Access Compliance Report

Public Rights-of-Way

(Curb Ramps)

Intersection ID: 44046	Main Street: LONGSTONE_LN	Cross Street: ARDREY_KELL_RD	Location: S
ADA ID: 99DC44666965	Ramp Type: PerpDiag	Initial Pass/Fail: Fail	Overall Compliance: No
		Severity Score: 70

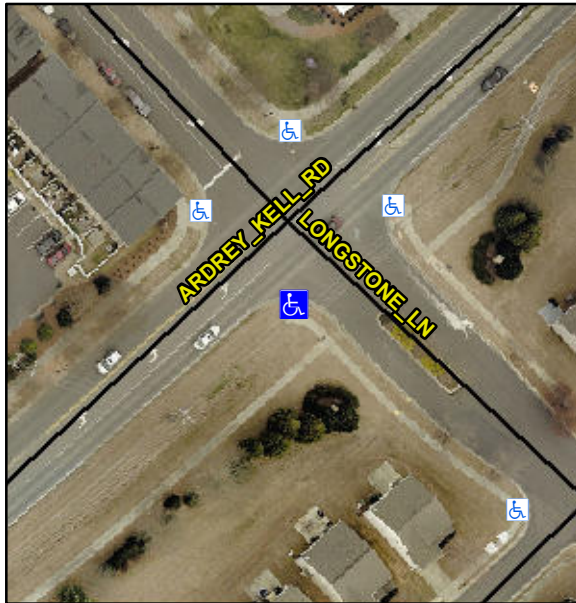
R304.5.1, R304.2.2, R304.5.3, R302.7

Compliance	Description	Data	Compliance	Description	Data
N/A	Ramp Length (in)	48.5	No	Ramp Slope (%)	12.2
No	Ramp Width (in)	35.5	No	Ramp XSlope (%)	5.3
N/A	Flare Type LT	N/A	N/A	Flare Type RT	N/A
N/A	Flare Slope LT (%)	N/A	N/A	Flare Slope RT (%)	N/A
N/A	Flare Traversable LT?	N/A	N/A	Flare Traversable RT?	N/A
N/A	Landing Length (in)	N/A	N/A	DWS Provided?	N/A
N/A	Landing Width (in)	N/A	N/A	DWS Contrast?	N/A
N/A	Landing Slope (%)	N/A	N/A	DWS Length (in)	N/A
N/A	Landing X Slope (%)	N/A	N/A	DWS Full Width?	N/A
N/A	Landing Curb? (Y/N)	N/A	N/A	DWS Offset (in)	N/A
N/A	Shared Landing?	N/A			
N/A	Gutter Ponding?	N/A	N/A	Gutter Slope (%)	N/A
N/A	Gutter Lip Ht (in)	N/A	N/A	Gutter X Slope (%)	N/A
N/A	Painted X Walk1?	No	N/A	Painted X Walk2?	No
	X Walk 1 Direction	To NE		X Walk 2 Direction	To NW
N/A	X Walk 1 Width (in)	N/A	N/A	X Walk 2 Width (in)	N/A
	X Walk 1 Slope (%)	2.9		X Walk 2 Slope (%)	4.8
	X Walk 1 X Slope (%)	6.0		X Walk 2 X Slope (%)	1.5

N/A	Ramp inside XWalk1?	N/A	N/A	Ramp inside XWalk2?	N/A
	Road Slope (%)	2.1	N/A	Clear Space?	N/A
	Road X Slope (%)	4.7	N/A	Clear Space to XWalk (in)	N/A
N/A	Any Obstructions?	N/A	N/A	Storm Grate/Utility Hazard?	N/A
	Obstruction Type			Storm Grate/Utility Type	
		N/A			N/A
		No		Surface Condition? (G/P)	Poor

Remove & Replace Curb Ramp With Two New Directional Ramps or Equivalent.
